APPENDIX D

Public Comments on Draft

Proposed Basin Plan Amendment

2005 Basin Plan General Update With Non-regulatory Revisions

Figure 3. Correlation Between Basins shown in Basin Plan and in USGS Reports.

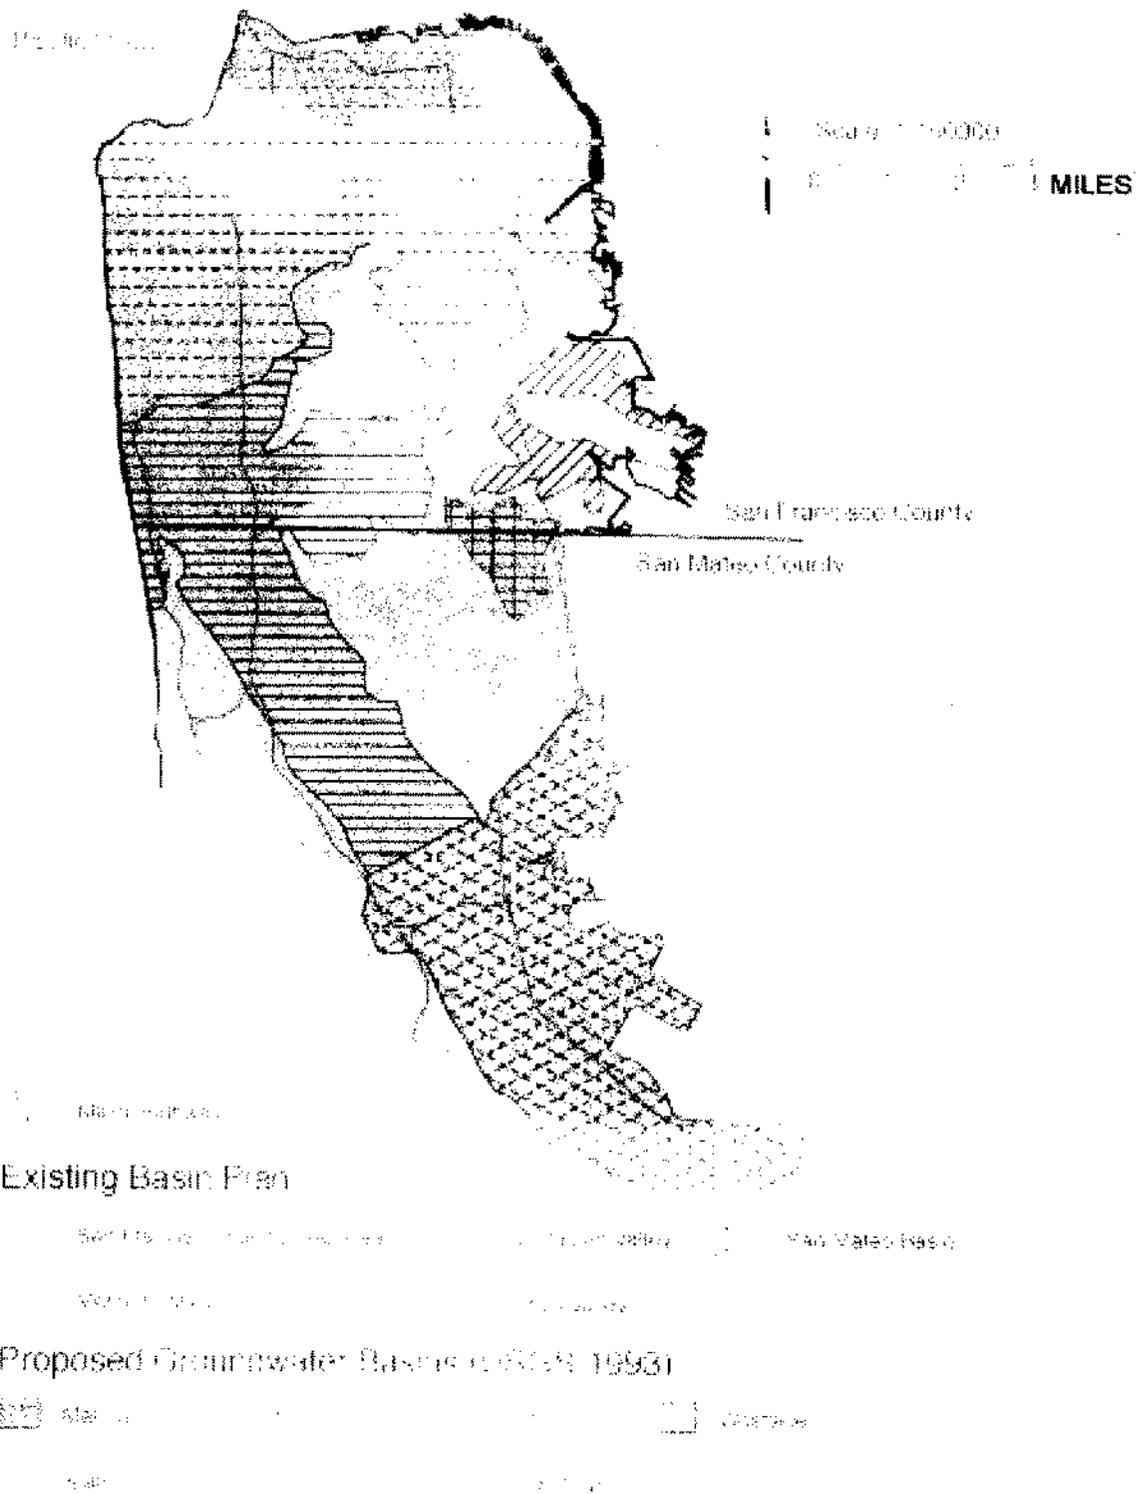
Comments on the proposed Basin Plan Amendments related to Groundwater Basin Outlines and Beneficial Use Designations. We have several concerns regarding updates to Table 2-3 “Existing and Potential Beneficial Uses of Groundwater in Identified Basins.” The intent of the updates appears to be motivated to make the groundwater basin outlines consistent with those shown in the new DWR Bulletin 118 (2004). However, several of the updates incorrectly apply the incorrect historic groundwater basin beneficial use designations to the new basin outlines. The attached map shows the 1995 Basin Plan outlines compared to the DWR Bulletin 118 (2004) outlines. Note that the DWR 118 (2004) outlines are based on the USGS (1993) report as updated by Water Board staffs “Comprehensive Groundwater Protection Evaluation for the South San Francisco Bay Basins (2003).”

For example, in the updated Table 2-3, the Merced Valley South is replaced with the San Francisco South Basin. This is an obvious error as the San Francisco South Basin was previously part of the Islais Basin and DWR split the former Islais Valley into the South and Islais Basins. The Merced Valley (South) should actually be part of the Westside Groundwater Basin. The confusion of the basins listed above results in the Westside Groundwater Basin having a “potential” MUN designation, when in fact it is an “existing” MUN beneficial use for 200,000 residents in San Mateo County. On the other hand, the newly defined Downtown Basin is shown to have an Existing MUN beneficial use when in reality there is no existing MUN beneficial use in the Downtown Basin.

We recommend that Table 2-3 be revised to be consistent with DWR Bulletin 118 (2004) the underlying USGS (1993) report, and the 2003 Water Board staff report.
